**AGENDA PACKET**

**DECEMBER 20, 2022 MEETING**

**AGENDA**

**Tuesday, December 20, 2022**

**1 DETAILED SITE PLAN**

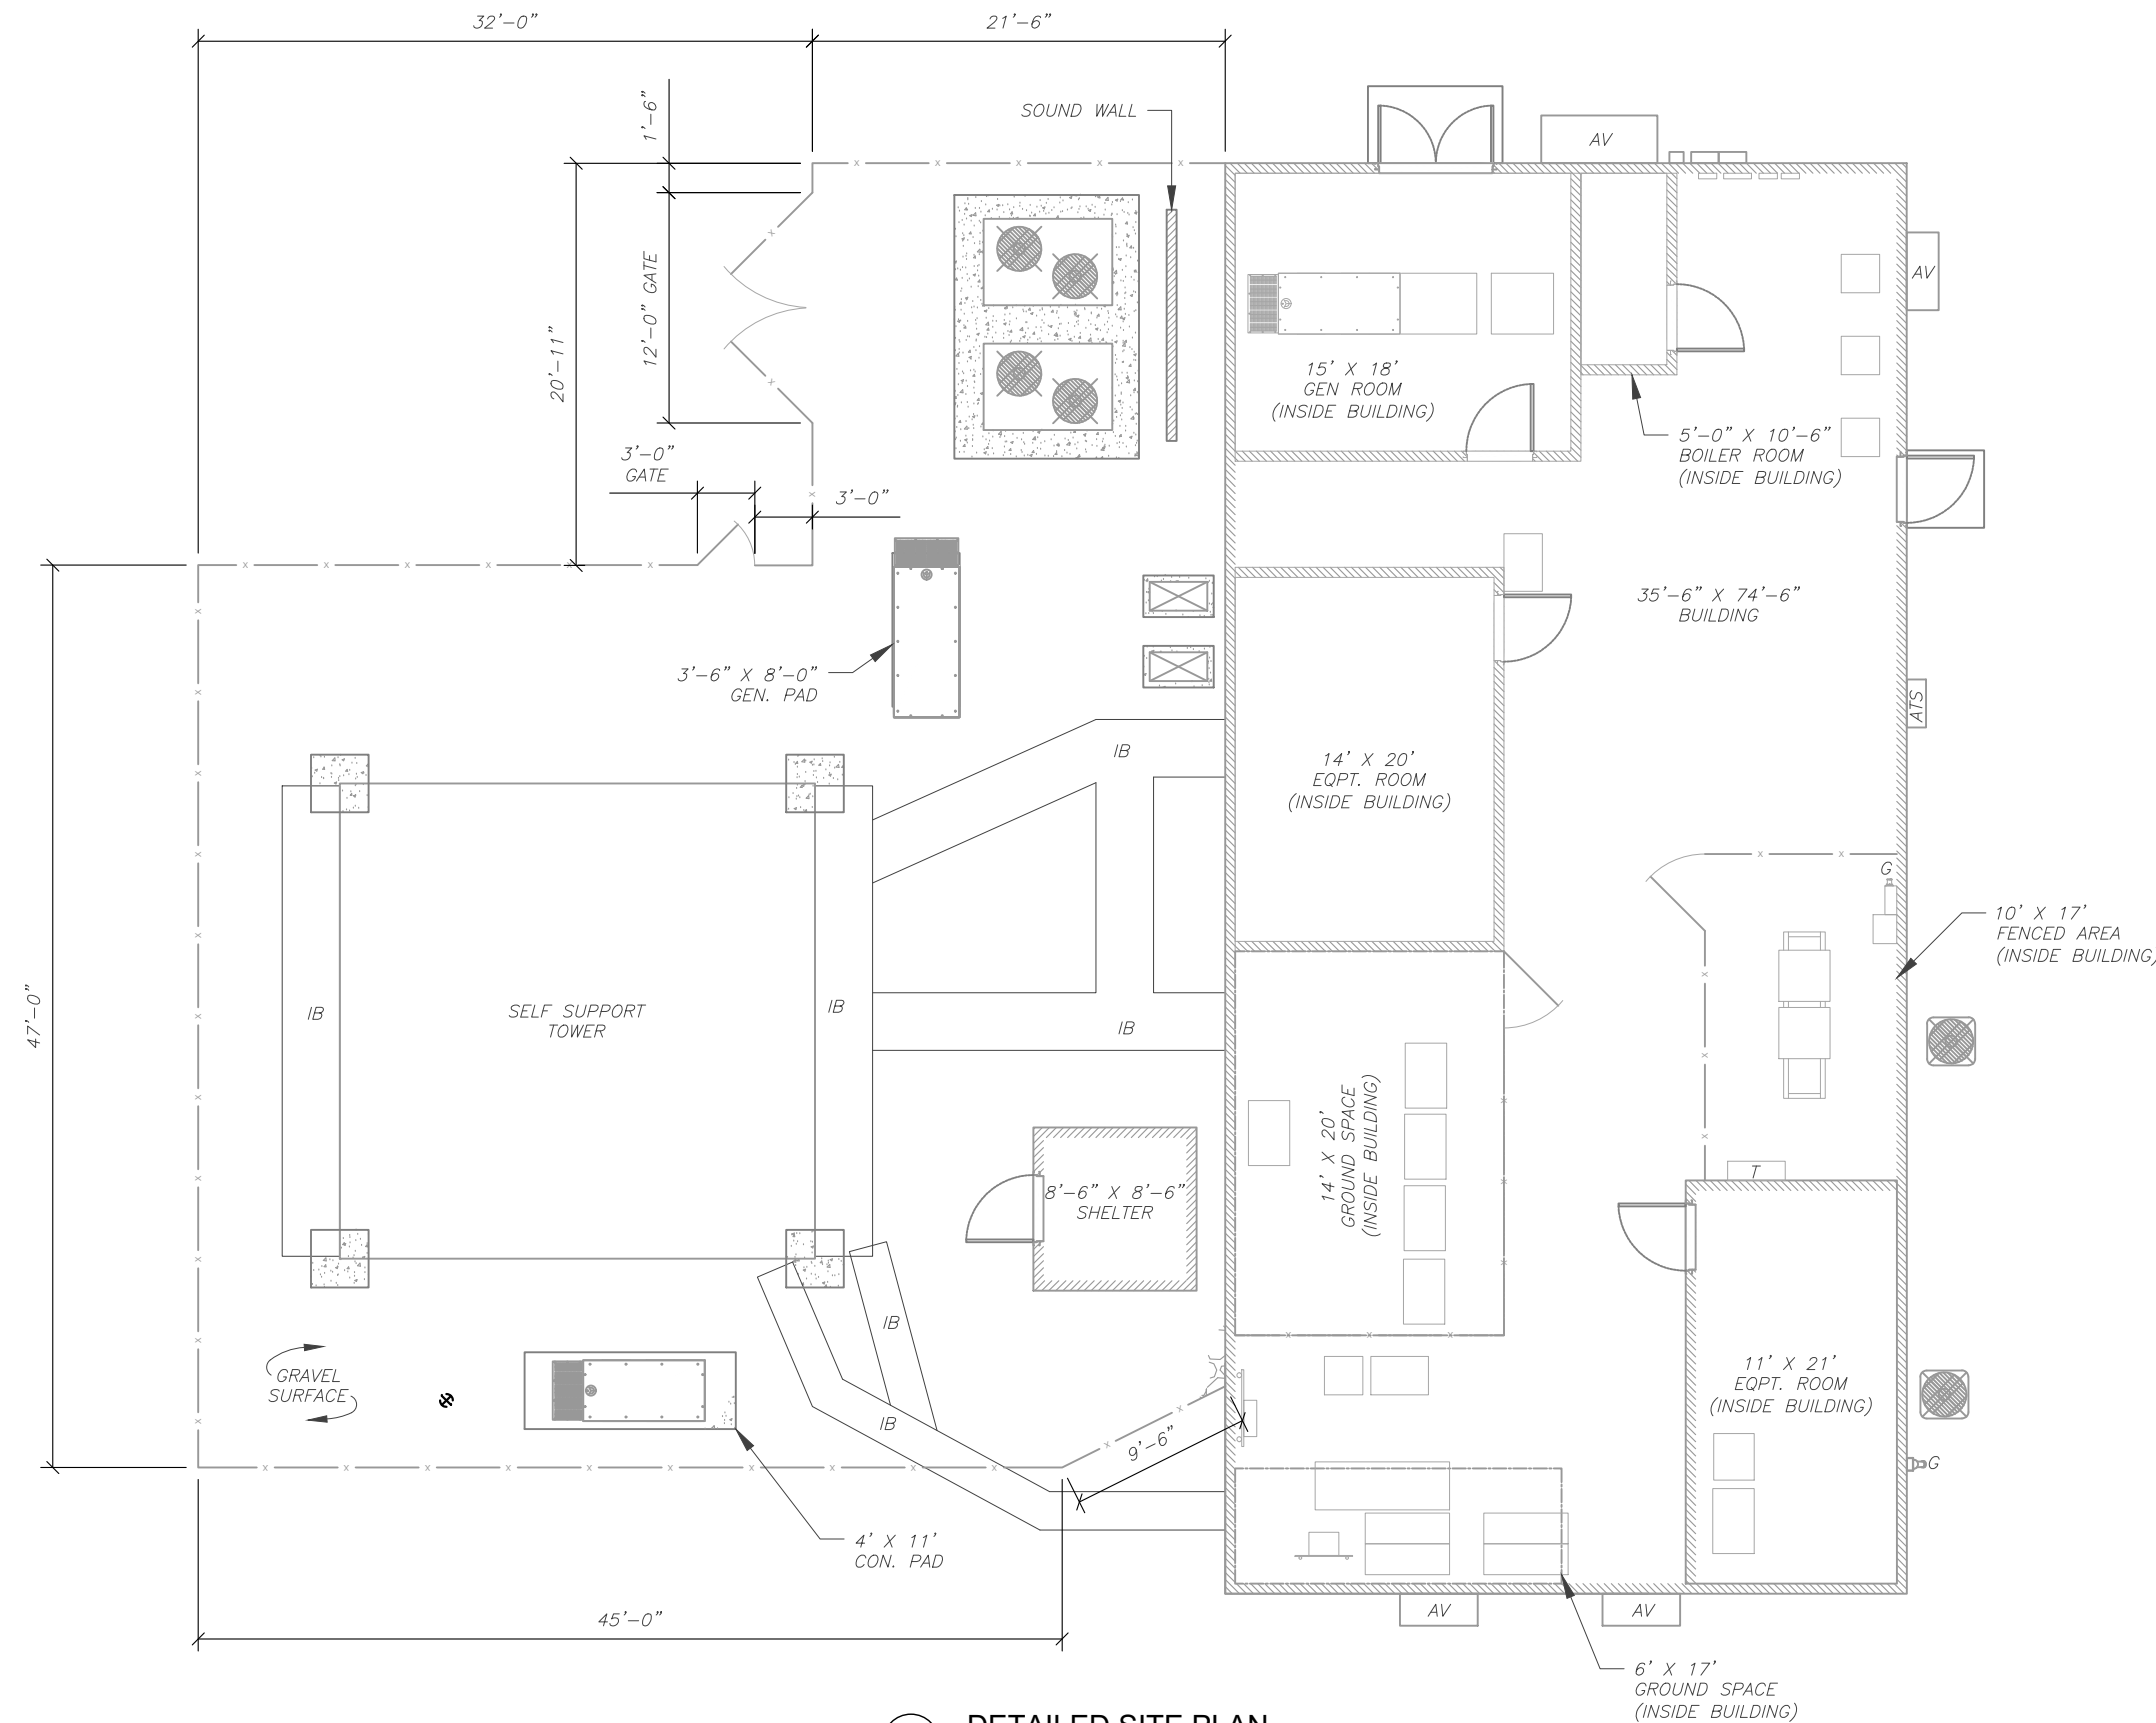
3. The Detailed Site Plan (Sheet C-101) should be revised to name the features illustrated, as well as identifying the wireless carrier in which they serve.

C-102

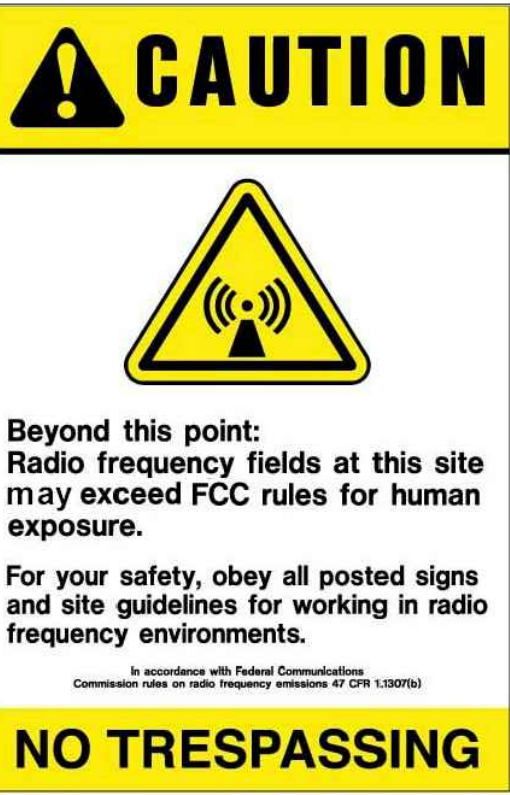
4. The Tower Elevation Plan (Sheet C-102) shall identify each carrier and list the existing equipment installed for each. Please ensure this elevation and carrier information/equipment is consistent with that provided within the structural report.

Figure 1

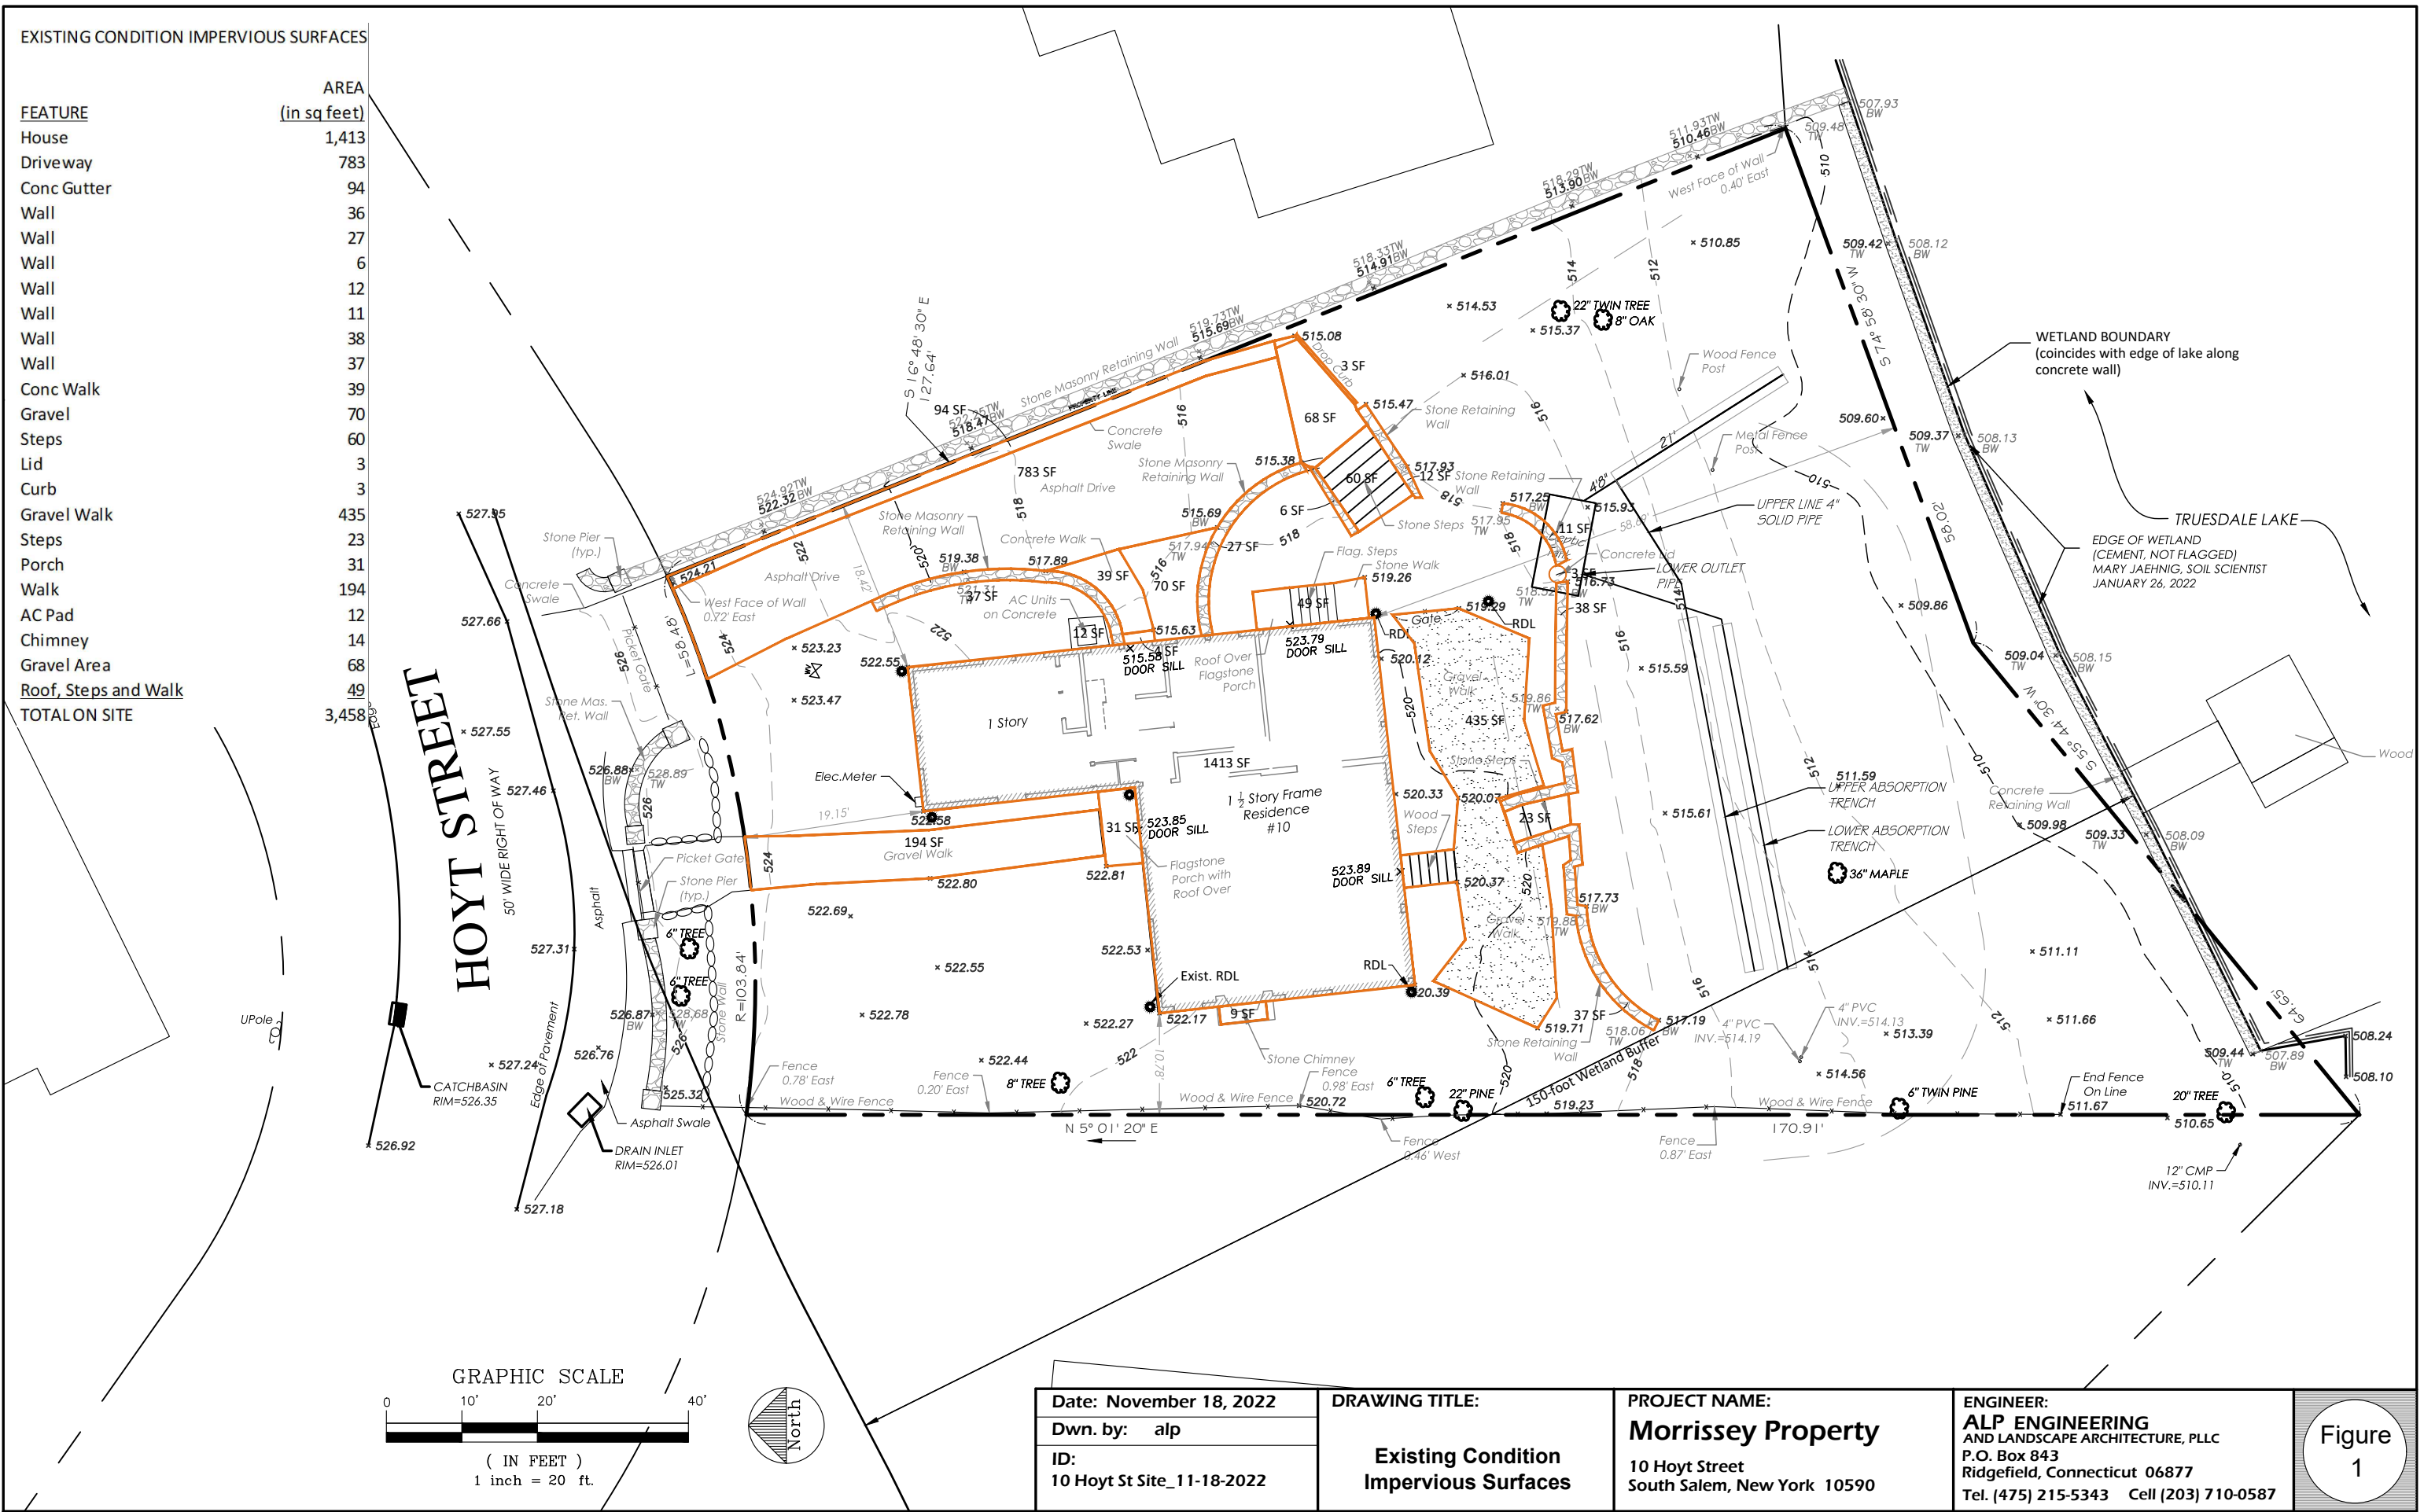
10. The existing impervious cover calculation provided on Figure 1 should not include existing gravel areas as impervious cover; please adjust the Figure and associated net increase calculations and ensure that appropriate curve numbers for existing conditions are used in the drainage calculations.

Figure 3

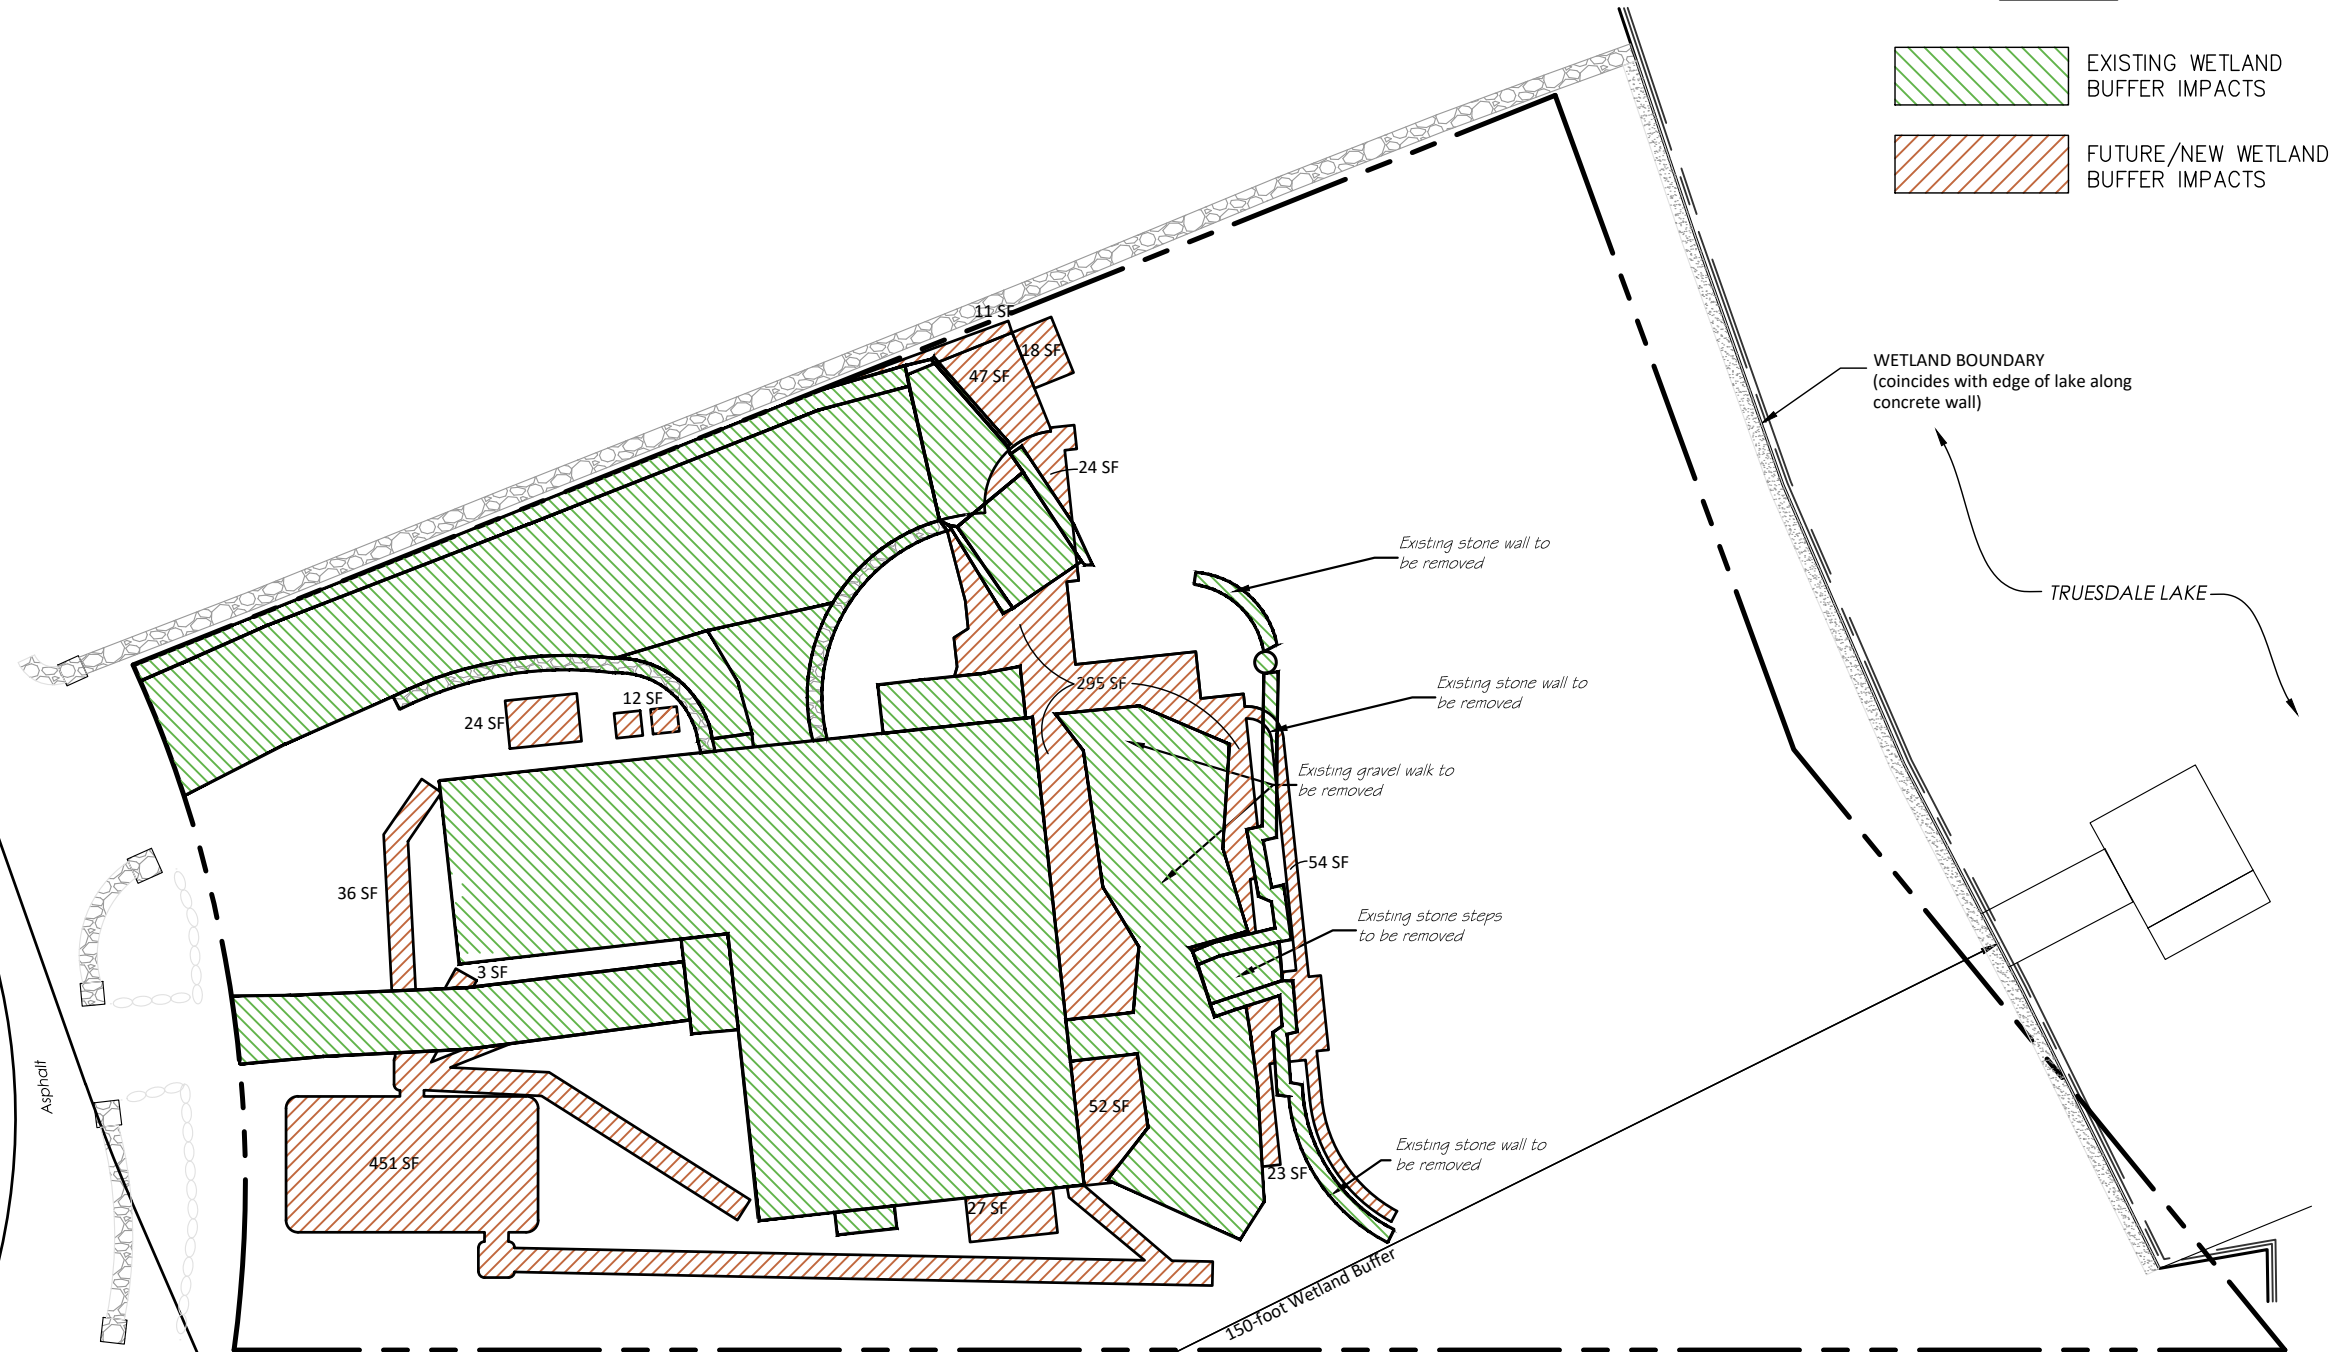
2. The wetland buffer impacts calculated on the site plan do not match the calculation on Figure 3. The Planning Board standard for mitigation on lake front properties includes the establishment of a planted buffer along the lake edge. Therefore, it is recommended that the planting areas provided along each side property line be extended to include more of the lake frontage; typically, a 10-foot wide planting area is recommended.
